17-37 WILLIAM ROAD | LONDON

SECTION 96A APPLICATION: DESIGN & ACCESS STATEMENT

24158-56T-P8-XXX-R-A-001-P04
05.02.2025

4.2 PROPOSED NORTH ELEVATION

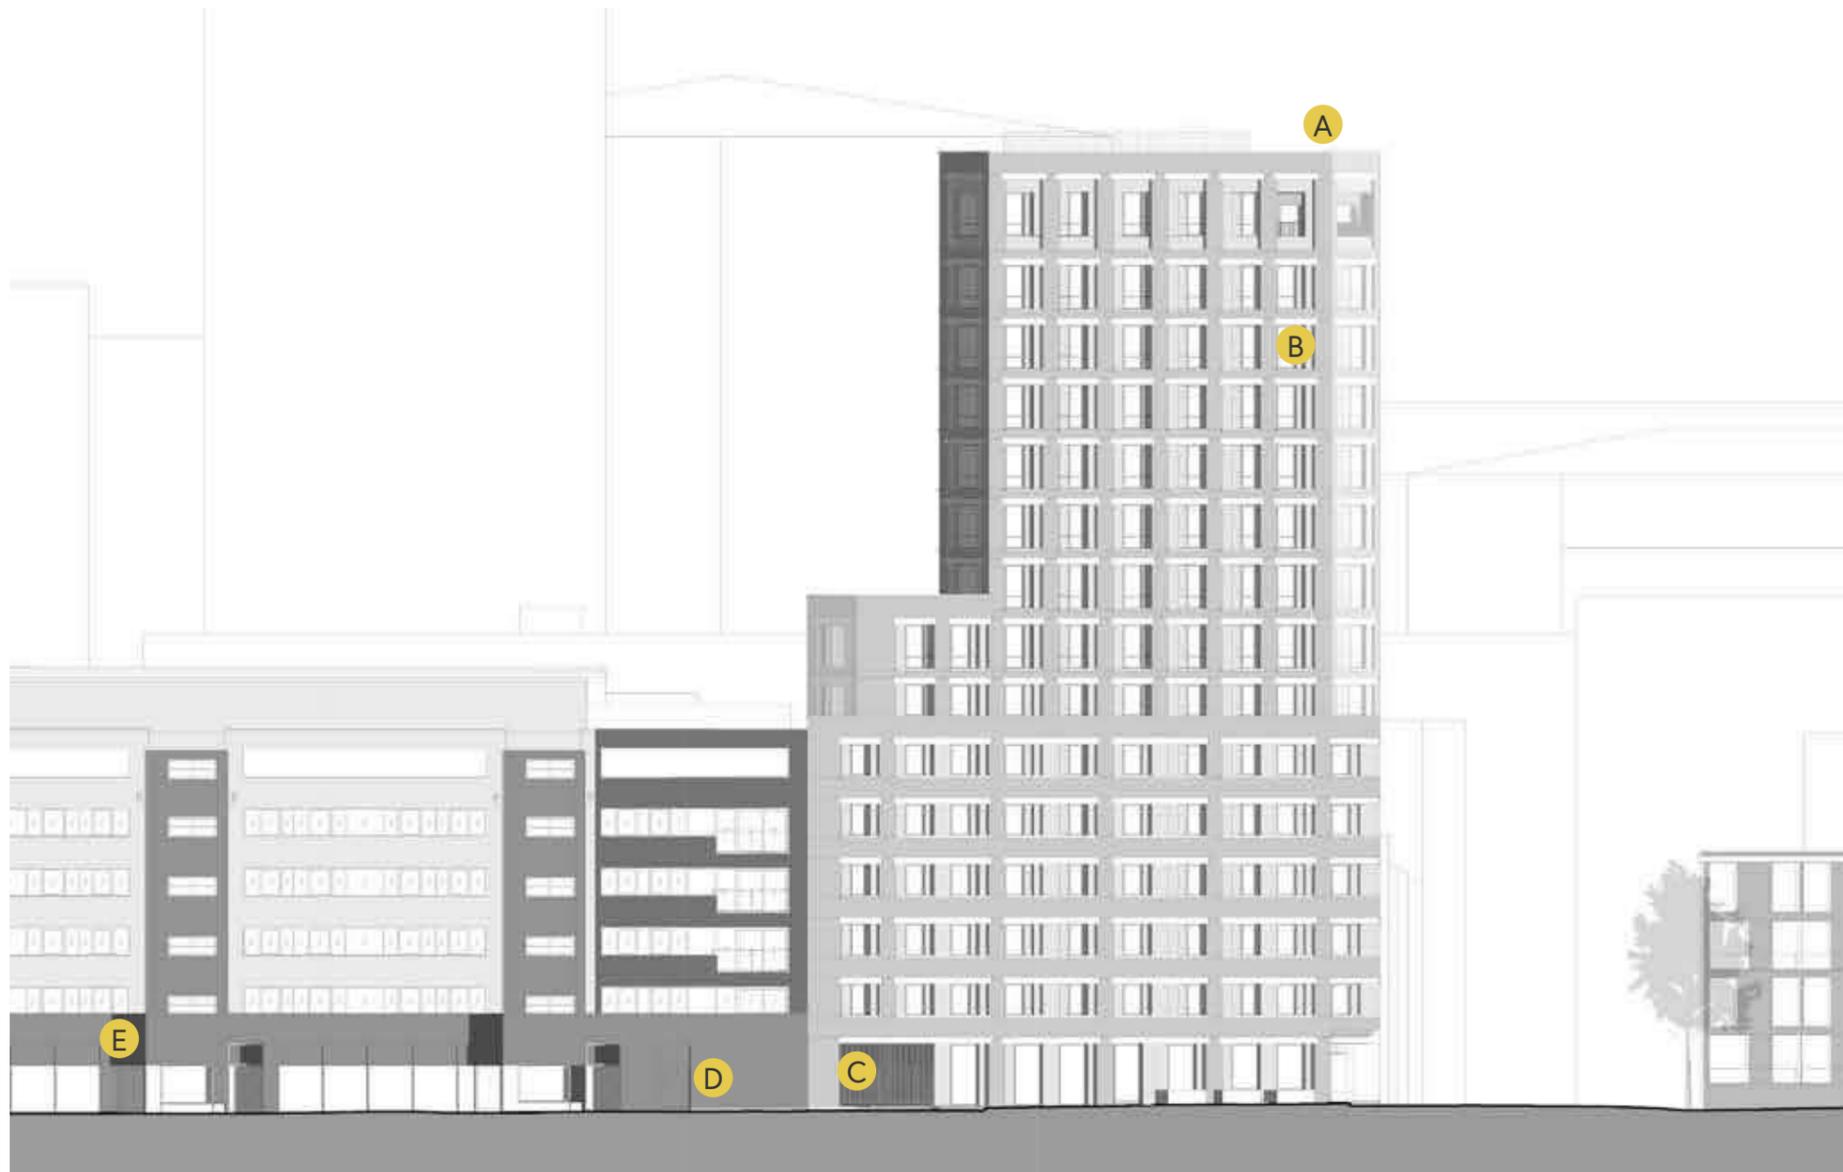
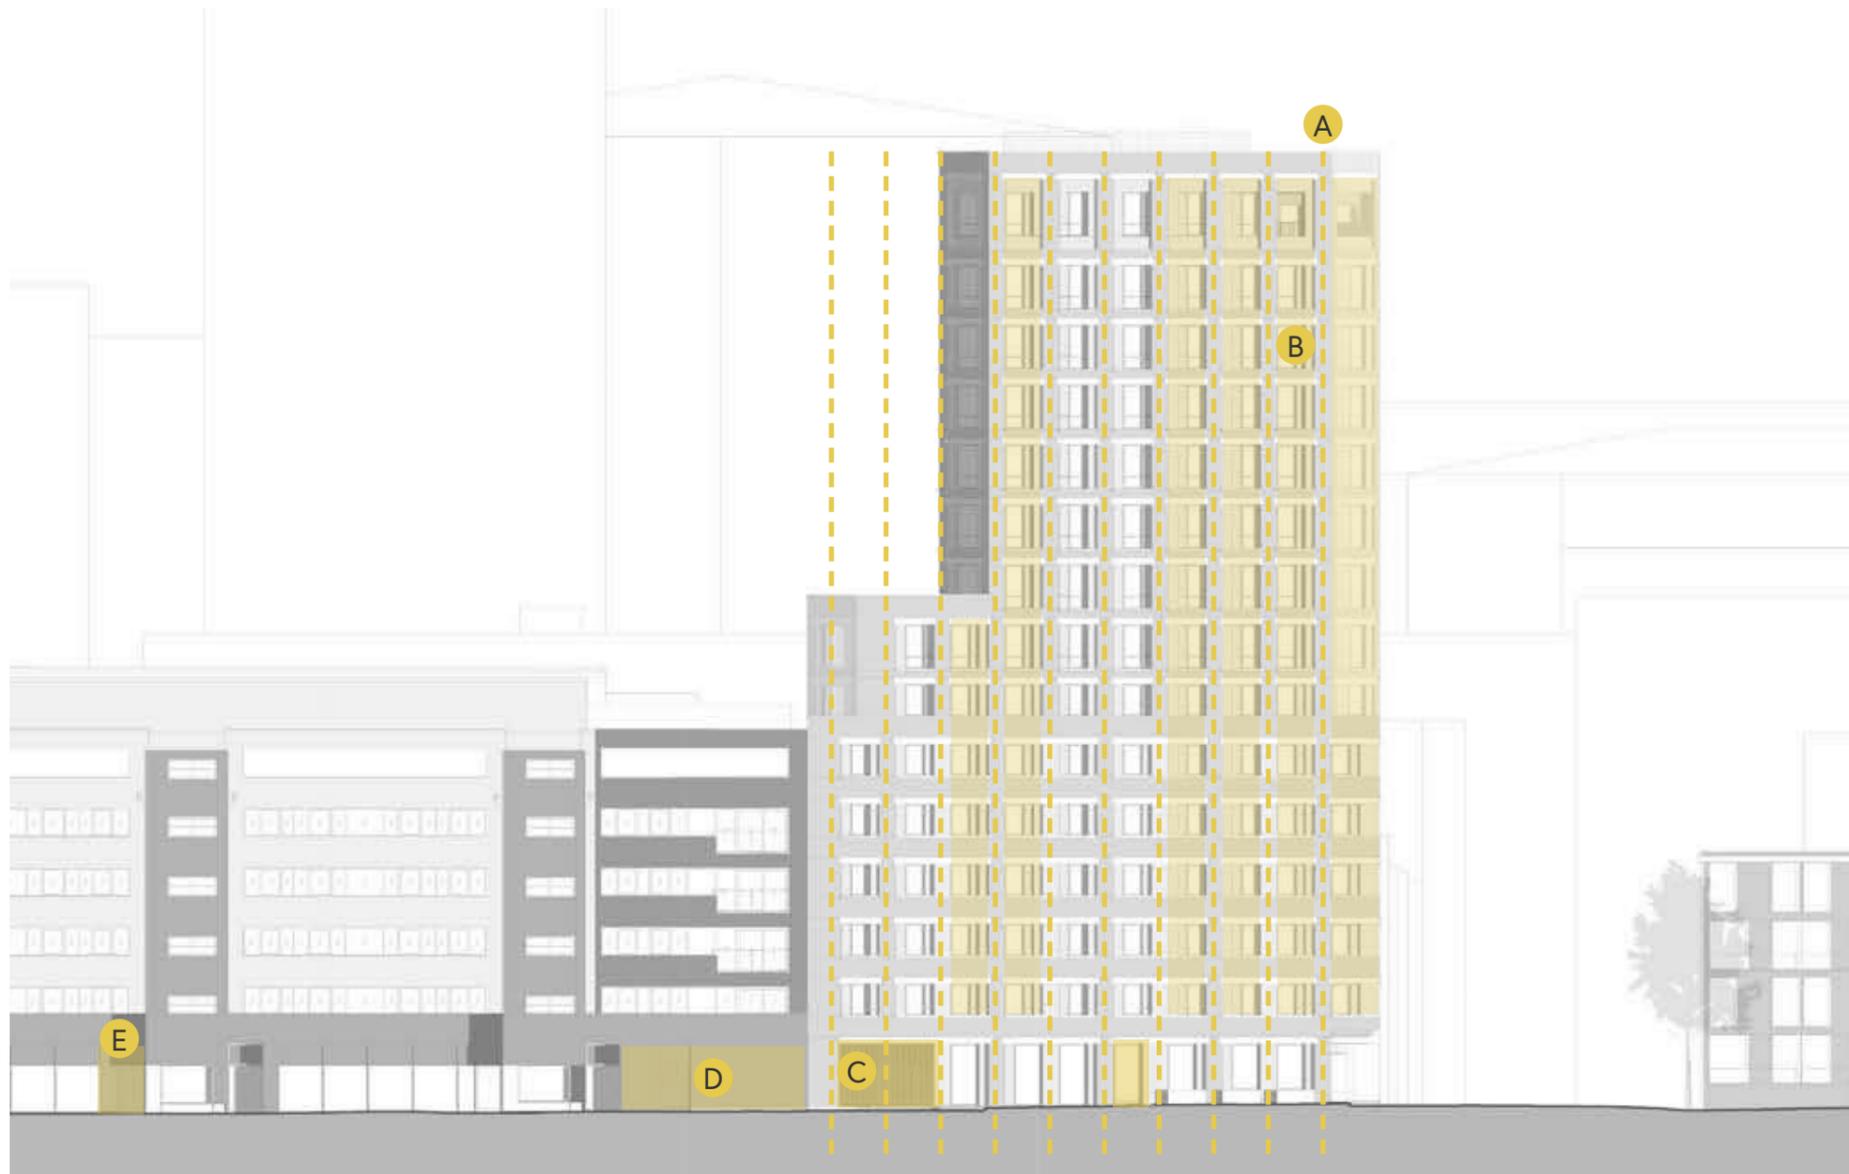
- A. Verticality of elevation is retained with the consented facade's pier widths and spacing remaining unchanged.
- B. Window bays are mirrored in certain locations to accommodate internal adjustments as described previously. Window openings remain as consented with Window, Vent and Recessed Brick Panel layout adjusted.
- C. Ground Floor Window Bays adjusted to accommodate access into the courtyard. A metal gate is proposed to provide security whilst continuing the vertical alignment from the pier above with subtle differences within the metal fin spacing.
- D. Existing building facade retained as existing due to the cycle store, bin store and substation no longer being relocated.
- E. Additional door to accommodate bin store.

The areas affected from alterations discussed above are highlighted adjacent in yellow. The retained alignment of piers is clearly retained indicated by the dashed yellow line.

A / Proposed South Elevation

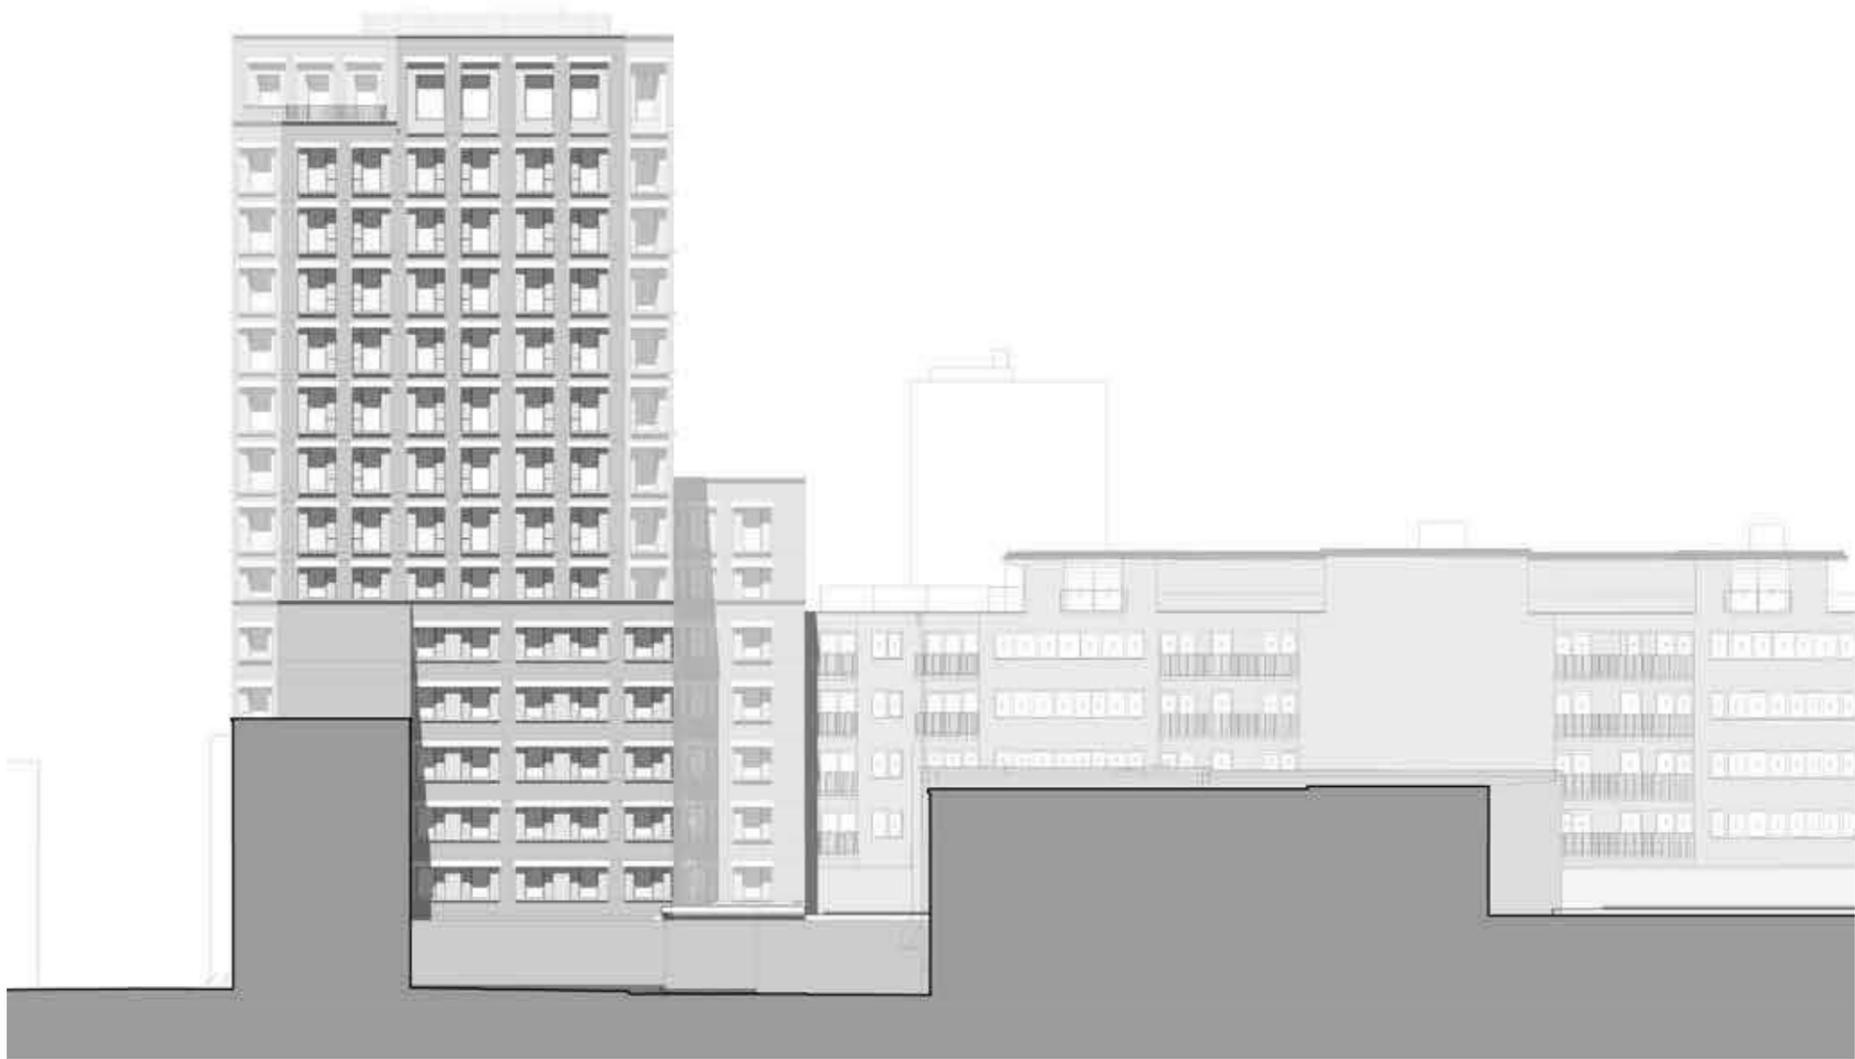
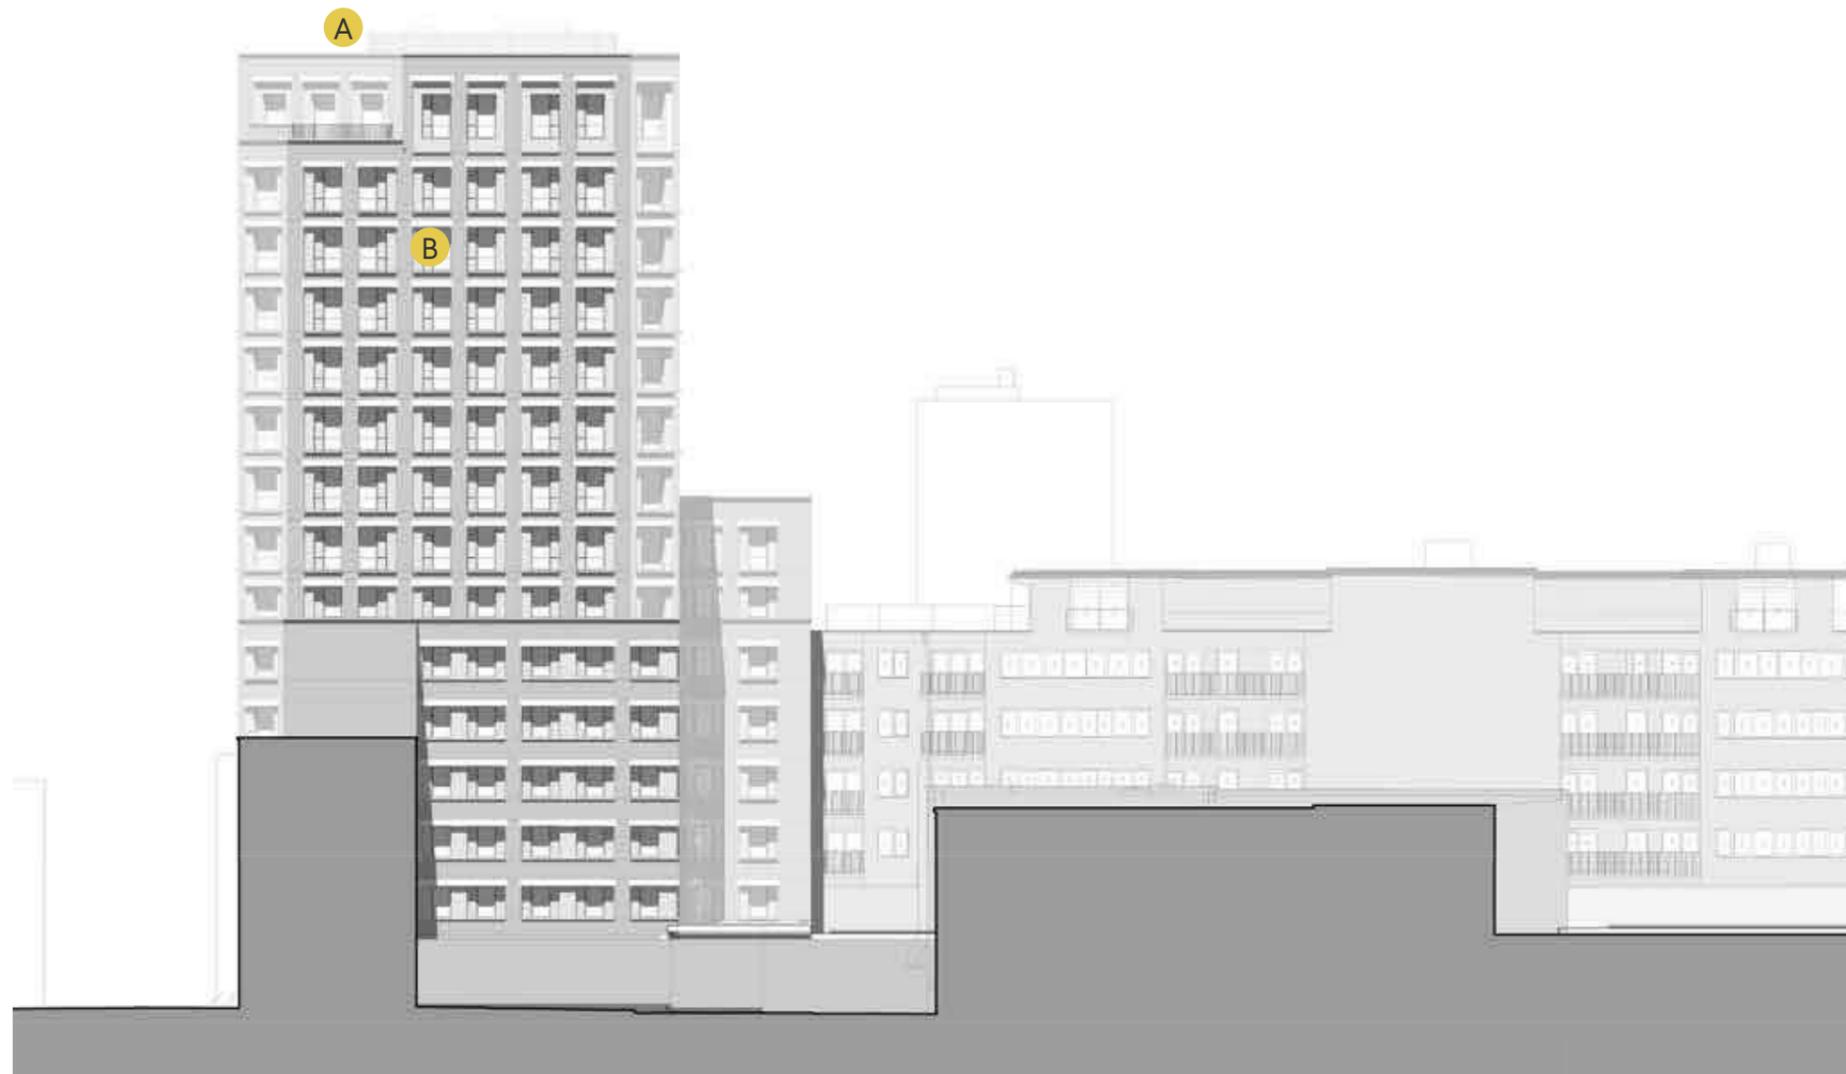
- A. Verticality of elevation is retained with the consented facade's pier widths and spacing remaining unchanged.
- B. Window bays are mirrored in certain locations to accommodate internal adjustments as described previously. Window openings remain as consented with Window, Vent and Recessed Brick Panel layout adjusted.

The areas affected from alterations discussed above are highlighted adjacent in yellow. The retained alignment of piers is clearly retained indicated by the dashed yellow line.
